SERVICE BULLETIN

TR-9130 Low Drive Level

7-05-83

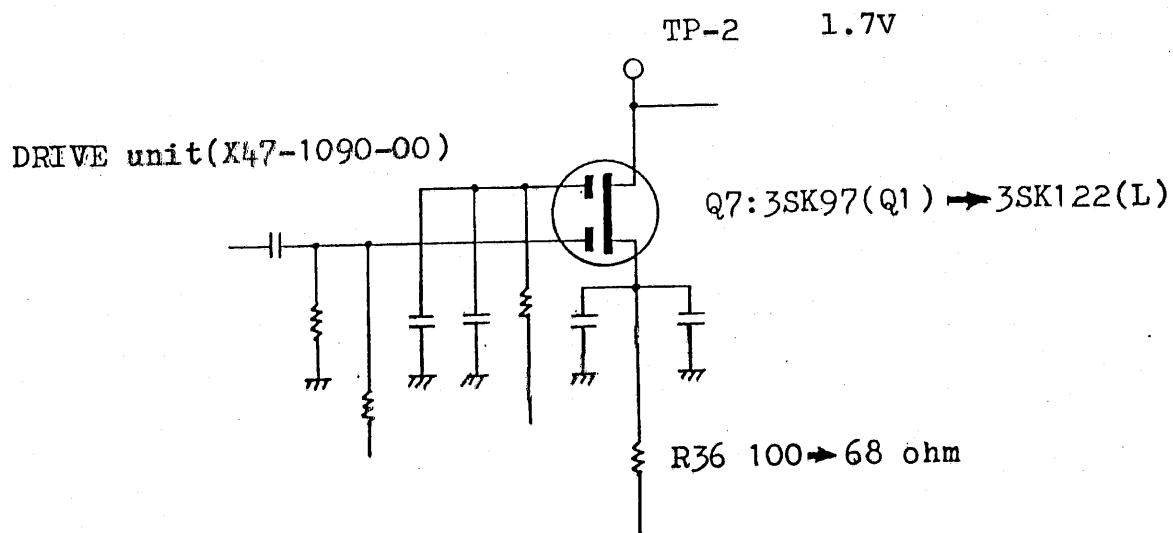
For reported cases of low transmit power output check the level of the TX driver transistor Q7 of the DRIVE unit (X47-1090-00). If the TX drive level is low make the following changes.

Old Part

Q7: 3SK97 (Q1)
R36: 100Ω

New Part

3SK122 (L)
68Ω (RD14BB2E680J)
